## **Project Memorandum**

<b>To:</b>	<b>KGHM Ajax Mining Inc.</b>	<b>Doc. No.:</b>	<b>BGC-022</b>
<b>Attention:</b>	<b>Nettie Ore</b>	<b>cc:</b>	
<b>From:</b>	<b>Cassandra Koenig</b>	<b>Date:</b>	<b>December 13, 2016</b>
<b>Subject:</b>	<b>Ajax Project EA/EIS - Responses to Round 2 Information Requests from FLNRO</b>		
<b>Project No.:</b>	<b>1125011</b>

**Figure 1: Summary of EA timeline, upcoming Project phases and proposed timeline to complete additional groundwater quantity studies**

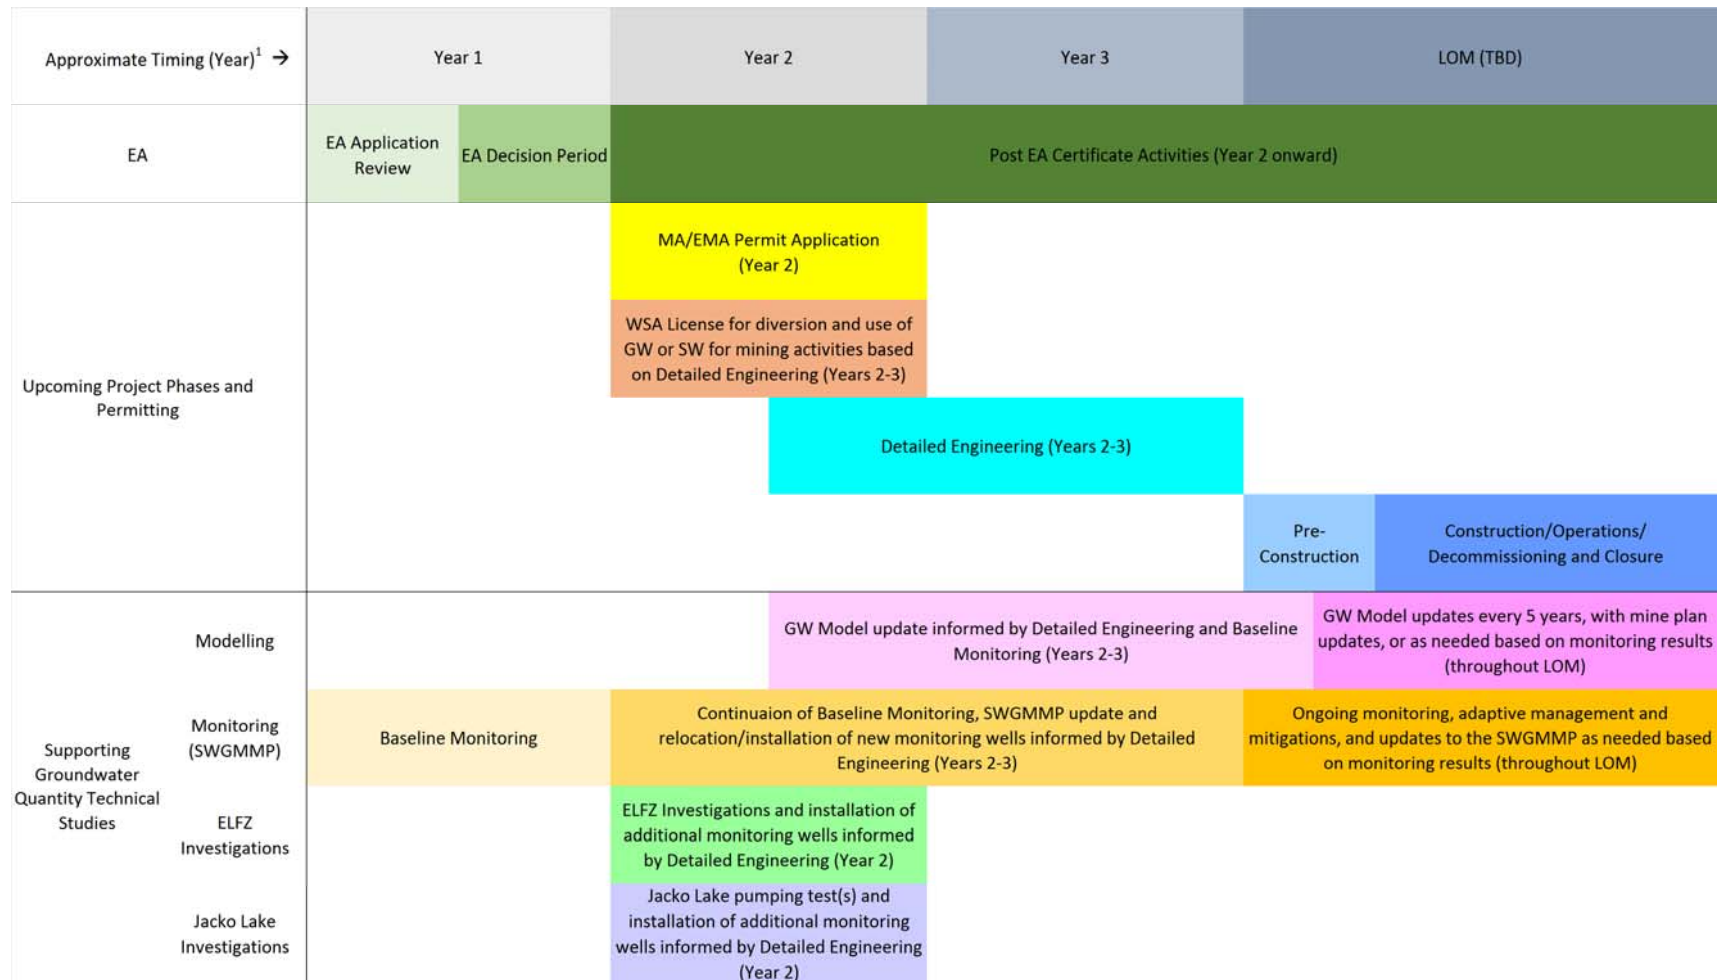
A proposed preliminary schedule integrating the concerns raised by FLNRO is provided in Figure 1.
